**FLOOD CONSEQUENCE ASSESSMENT (FCA)  
& DRAINAGE STRATEGY**

**UPPER COSMESTON FARM**

**CC1857-CAM-ZZ-XX-RP-C-00-0001**

# MEMORANDUM / COFNOD

Project:  
UPPER COSMESTON FARMDrawing Title:  
SUSTAINABLE DRAINAGE  
STRATEGY CONCEPTDrawing No.  
CC1857 CAM ZZ XX SK C 52 0125

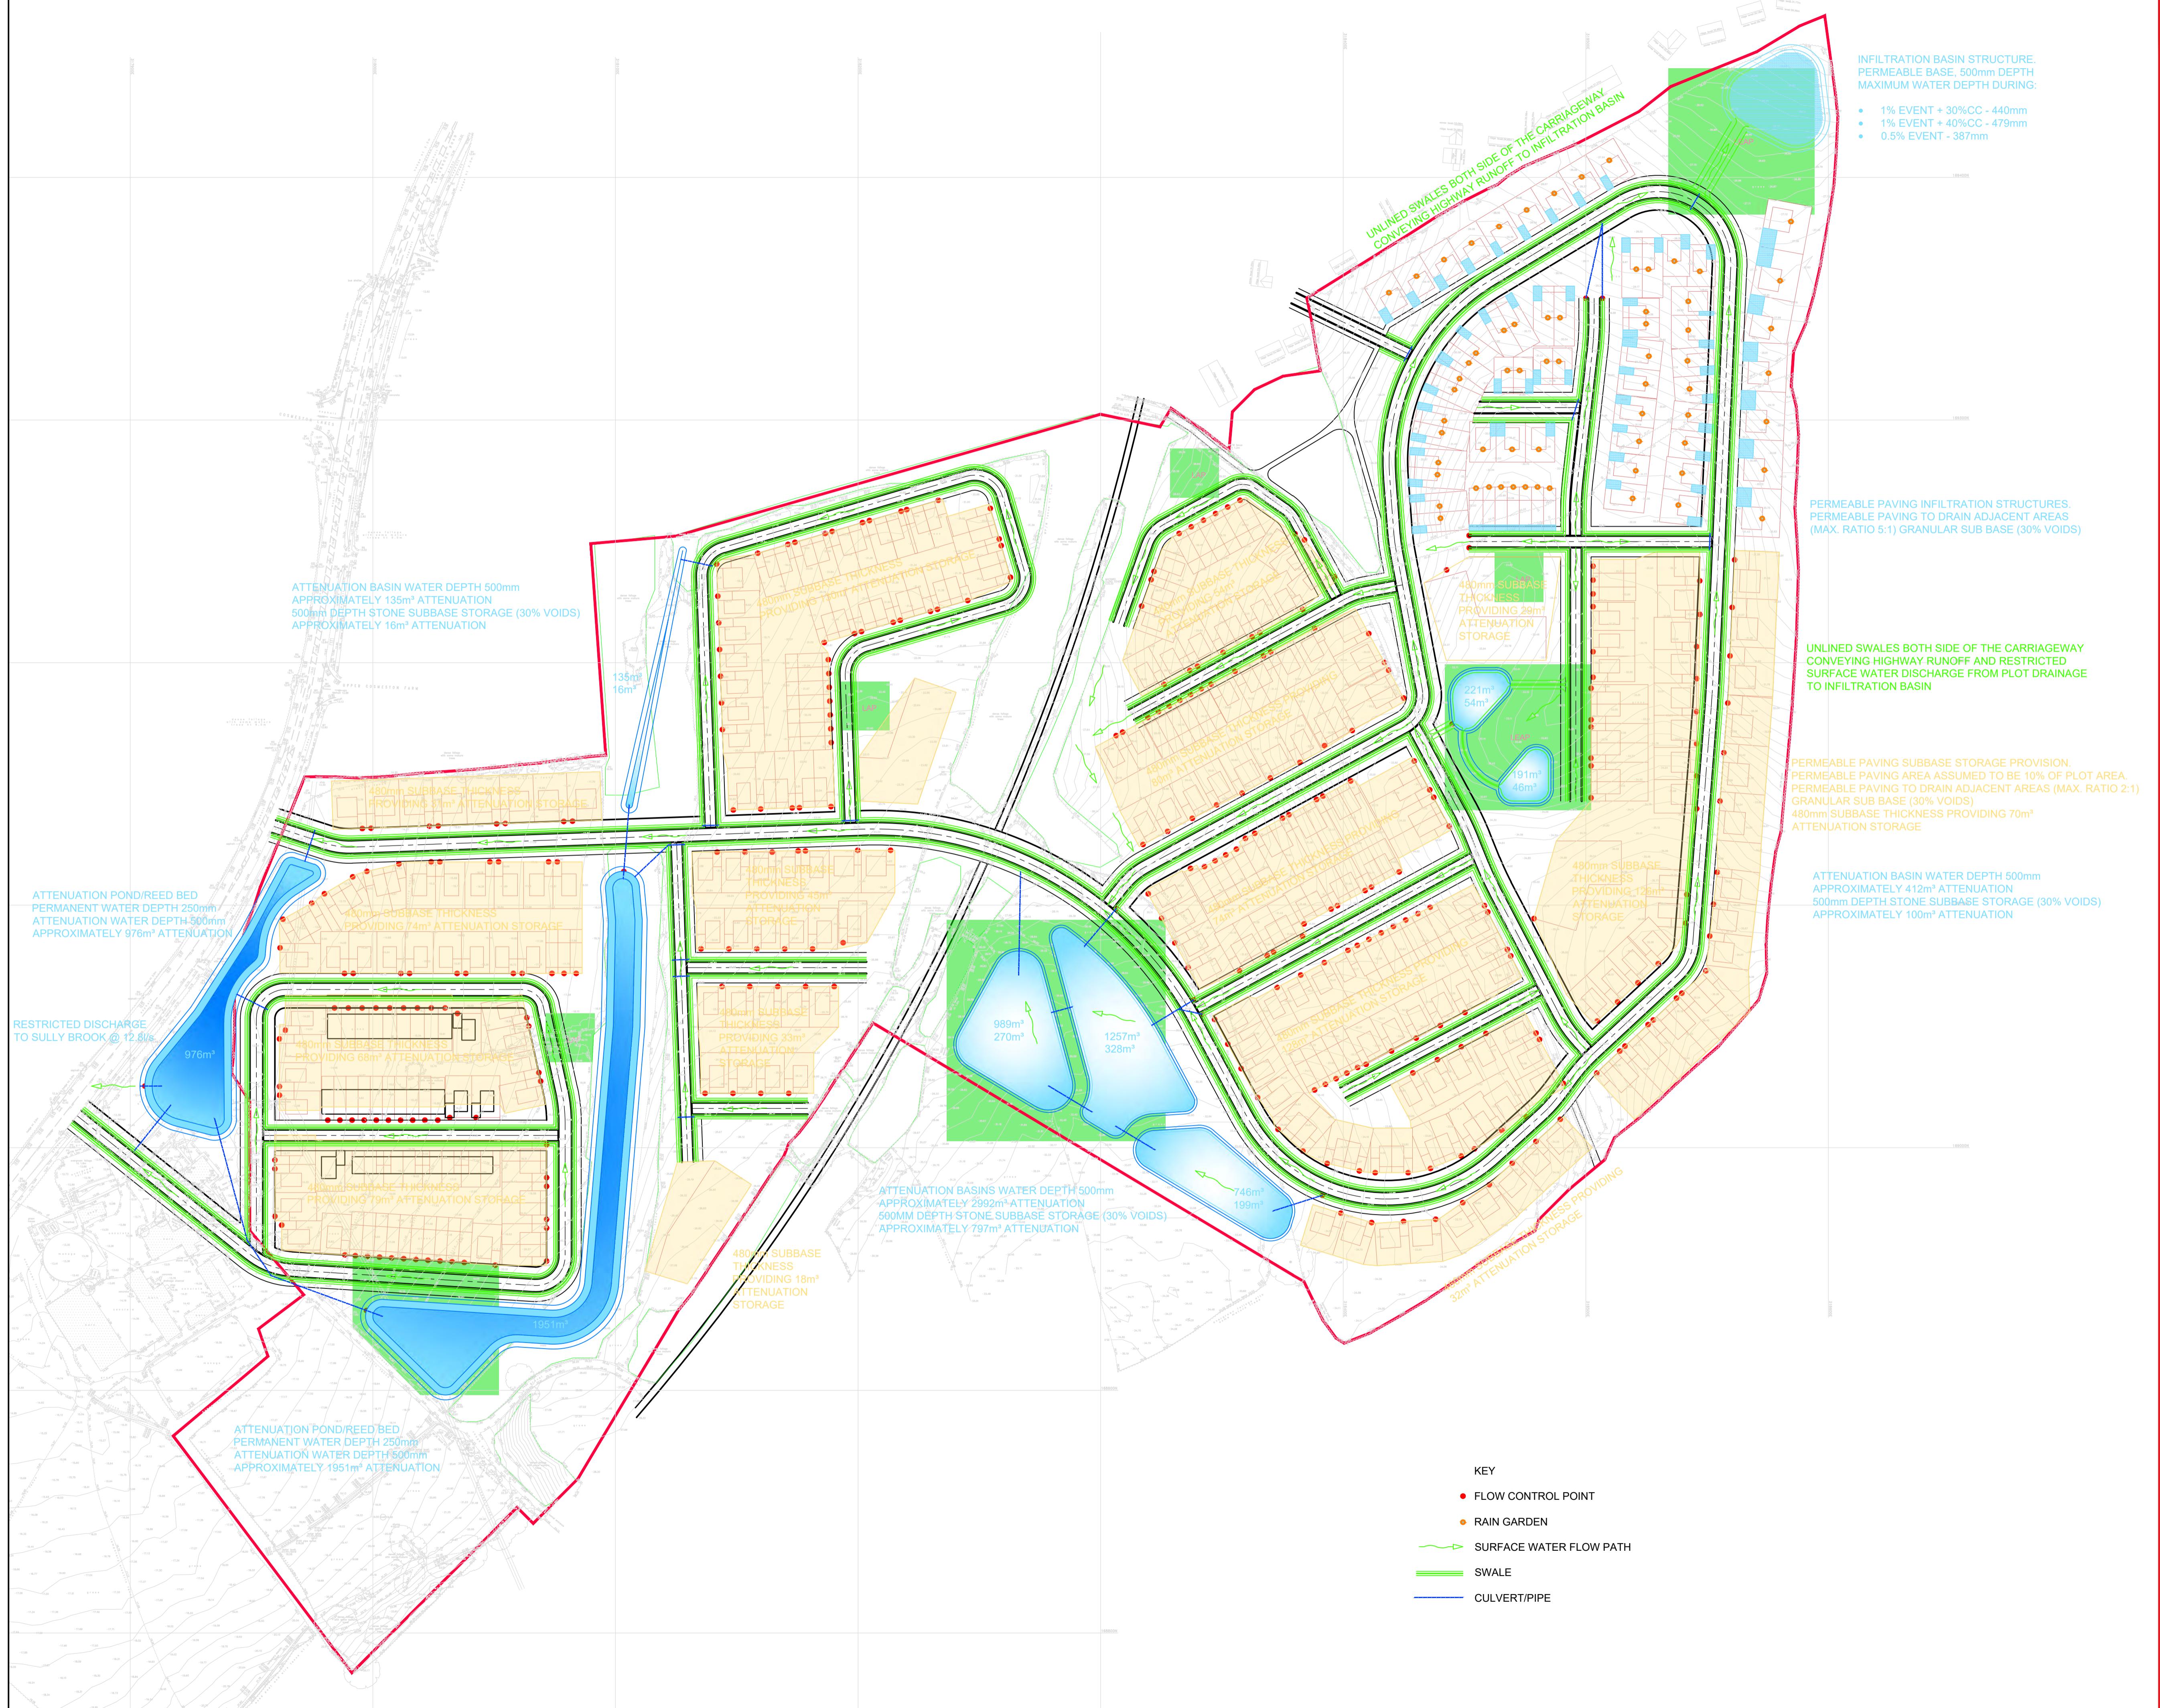
The submitted drainage concept drawing identifies the location of an infiltration basin on the northern boundary of the site. NRW flood mapping has indicated that Whitcliffe Drive directly north of the proposed basin is situated in an area of high flood risk. This is also supported by our historical records which documents a known flood incident at Whitcliffe Drive during March 2013. Due to the proximity of the basin to a known flood risk area together with unsuccessful infiltration testing at the location (E-TP25) we hold concerns regarding the positioning of the infiltration basin in relation to the properties at Whitcliffe Drive. On full application we would require the potential impact on flood risk offsite towards Whitcliffe Drive to have been fully considered. This could potentially require a change in the form or location of drainage features serving this area of the development.

It is also noted within the concept drawing that the northern swales adjacent to the central attenuation basins drain to an overland flow path. Further detail is required with regard to this overland feature and it will be the intention of the Vale of Glamorgan Council to explore the potential designation of this feature in order to protect the area from any future alterations.

The Typical SuDS Construction Detail plan submitted with this application proposes the use of a stone / crushed rock layer at the bottom of the basins. In order to maximise amenity benefits for future residents we would request that the stone layer is removed from the basin and that the any basins takes on a more natural look where possible.
